Access Compliance Report

Public Rights-of-Way

(Curb Ramps)

Intersection ID: 14033	Main Street: ELMIN_ST	Cross Street: MORNING_DR	Location: NW
ADA ID: 992518482B39	Ramp Type: PerpDiag	Initial Pass/Fail: Fail	Overall Compliance: No
Severity Score: 58.75			
Codes/Mitigation Info/Possible Solution		Field Measurements/Component Compliance

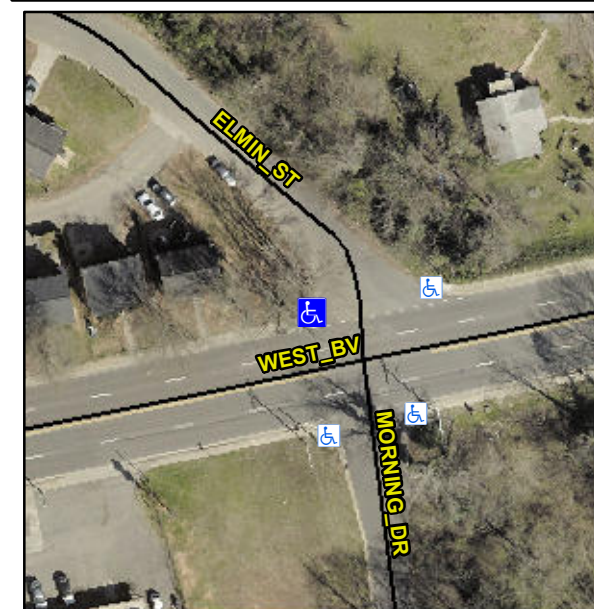
Not Found, R304.5.1, R304.2.2, R304.5.3

Compliance	Description	Data	Compliance	Description	Data
N/A	Ramp Length (in)	48.0	No	Ramp Slope (%)	14.7
No	Ramp Width (in)	42.0	No	Ramp XSlope (%)	17.0
N/A	Flare Type LT	N/A	N/A	Flare Type RT	N/A
N/A	Flare Slope LT (%)	N/A	N/A	Flare Slope RT (%)	N/A
N/A	Flare Traversable LT?	N/A	N/A	Flare Traversable RT?	N/A
N/A	Landing Length (in)	N/A	N/A	DWS Provided?	N/A
N/A	Landing Width (in)	N/A	N/A	DWS Contrast?	N/A
N/A	Landing Slope (%)	N/A	N/A	DWS Length (in)	N/A
N/A	Landing X Slope (%)	N/A	N/A	DWS Full Width?	N/A
N/A	Landing Curb? (Y/N)	N/A	N/A	DWS Offset (in)	N/A
N/A	Shared Landing?	N/A			
N/A	Gutter Ponding?	N/A	N/A	Gutter Slope (%)	N/A
N/A	Gutter Lip Ht (in)	N/A	N/A	Gutter X Slope (%)	N/A
N/A	Painted X Walk1?	No	N/A	Painted X Walk2?	No
	X Walk 1 Direction	To S		X Walk 2 Direction	To E
N/A	X Walk 1 Width (in)	N/A	N/A	X Walk 2 Width (in)	N/A
	X Walk 1 Slope (%)	7.7		X Walk 2 Slope (%)	1.4
	X Walk 1 X Slope (%)	1.8		X Walk 2 X Slope (%)	8.3

Remove & Replace Curb Ramp With Two New Directional Ramps or Equivalent.
